From: Penelope Karagounis
Sent: Wednesday, June 10, 2015 9:40 AM
To: Alex J. Moore
Subject: FW: Avondale TIS Review
Attachments: Avondale Development TIS Comments.pdf

From: Gorrie, Jason R. [<mailto:gorriejr@pbworld.com>]
Sent: Tuesday, June 09, 2015 10:56 PM
To: Penelope Karagounis
Subject: Avondale TIS Review

TO: Penelope Karagounis
FROM: Jason Gorrie, PE
DATE: June 10, 2015
RE: Avondale Development Traffic Impact Study Comments

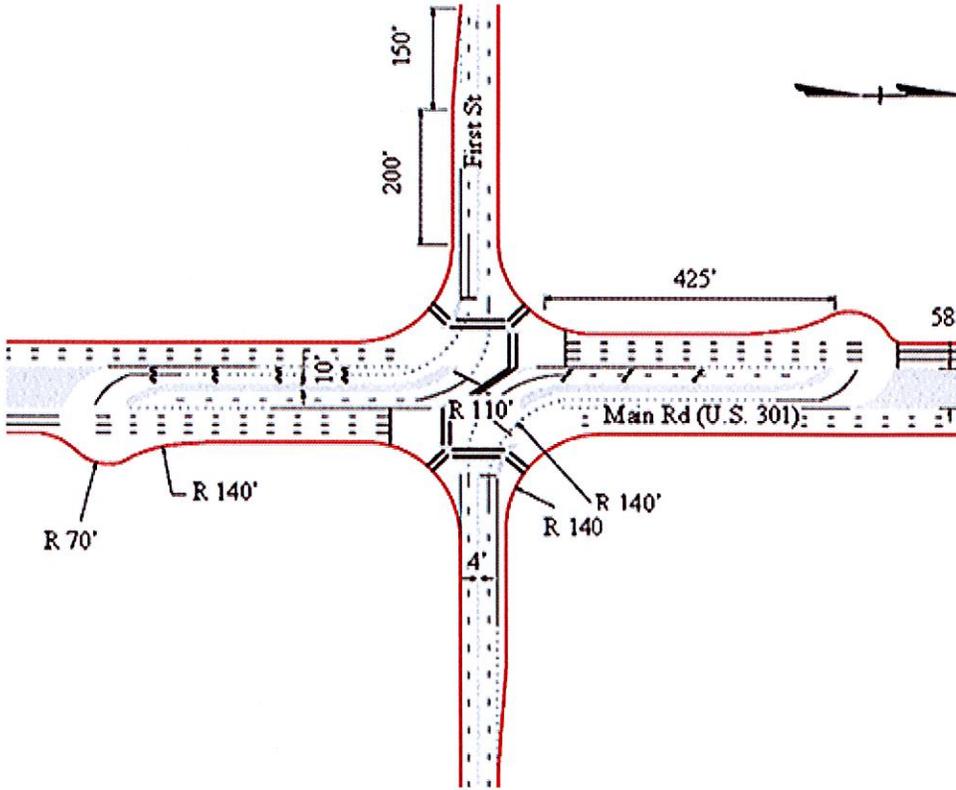
There is one item that I would like to discuss that I did not include in the official comments. I am concerned about the recommended improvements the developer proposes at the US 521 & SC 160 intersection. Below is a snap shot of the improvements in question. Based on the SCDOT Roadway Design Manual, providing an acceleration length of 580' seems appropriate for the triple lefts that would come from SC 160; however, a 540' taper would also be included in a typical acceleration lane design. In this case, the lane would drop at the Goodyear driveway. Dropping a lane into a driveway instead of providing a taper creates a safety concern with regard to merging traffic.

The decision on whether this is acceptable ultimately resides with SCDOT; however, I would recommend the examination of a Median U-turn (Superstreet) intersection design at the US 521 & SC 160. This option would restrict the Overhill Dr (WB) approach to the US 521 & SC 160 intersection to right-in/right-out, which would allow more green time to be redistributed to other movements at the intersection. Additionally, U-turn bulb-outs would have to be constructed approximately 500'-700' from the US 521 & SC 160 intersection. Below is an example of the Median U-Turn design. PB is currently working with NCDOT and the Town of Cornelius on the application of this design along Catawba Ave. Our Regional Traffic Manager also authored a paper on the Median U-Turn design for FHWA. I would be more than happy to further discuss the operational and safety benefits of the Median U-Turn design if the County or SCDOT would like more information on the design.
